PRODUCT BULLETIN: 1/8/08

RE: **JIMI ENHANCEMENTS**

1A: SPRING ASSIST

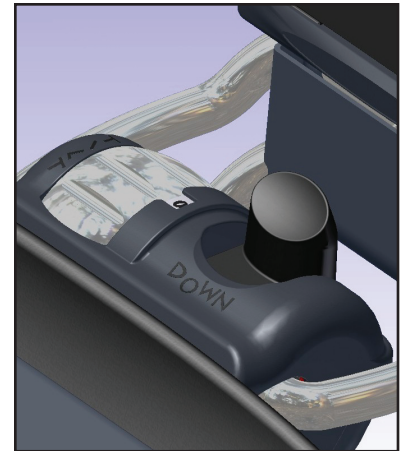
Workstuff has added a "spring assist" to all keyboard units. Adding the Spring Assist feature enhances the downward and upward adjustment of the product. Each JIMI product now has a counterbalanced feel:

Upward Adjustment: easier and effortless

Downward Adjustment: easier and smoother
just use your thumb to push "down button"
